619-523 CONGRESS STREET

CITY OF PORTLAND

Your application for a building permit to install a sprinkler system to serve basement and stairwell as per plans at 621 Congress Street, Portland, Maine, is being issued herewith subject to the following building and fire code requirements.

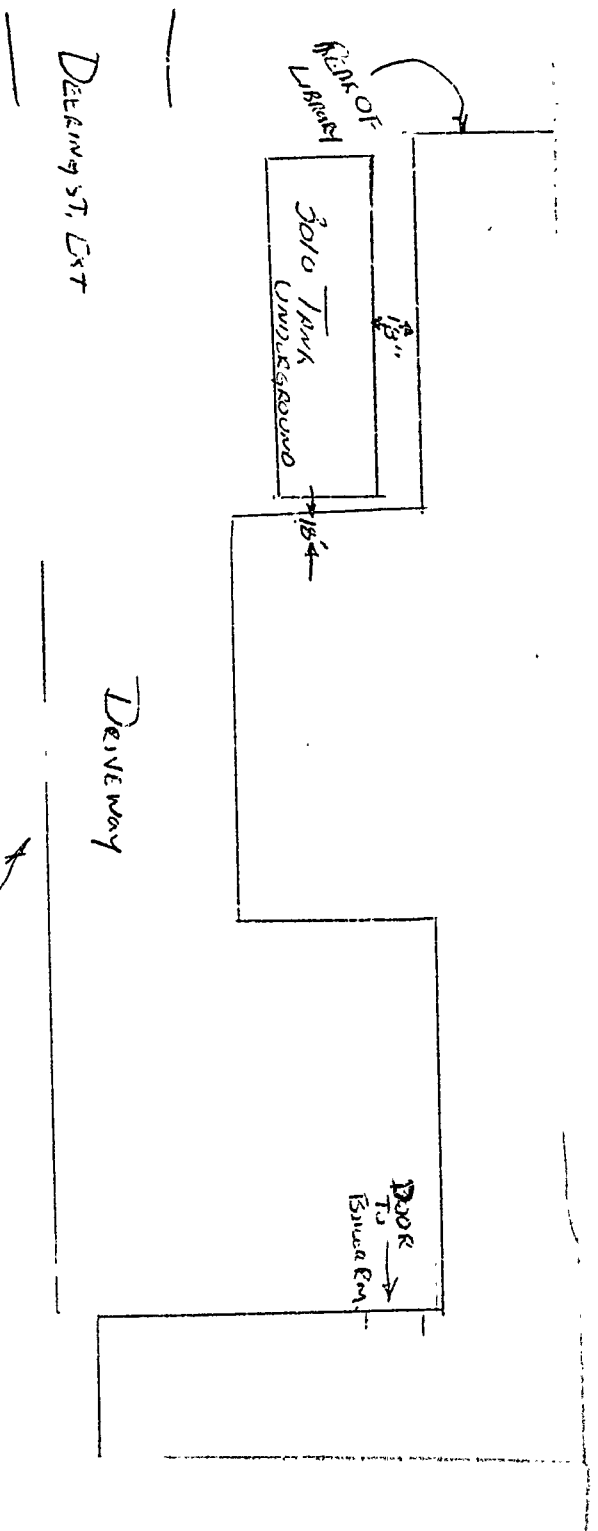
We note the 3,000 gallon underground tank is indicated at 18 inches off the foundation wall of the building and is to be buried with 3 feet of cover. As we do not know the diameter, we are not sure of the total depth to the bottom of the tank, and would like to make clear that in no case shall the tank bottom excavation be any lower than the footer of the building. If by any chance it is found that it will be lower than this, you are to notify this office how you intend to retain the existing foundation wall.
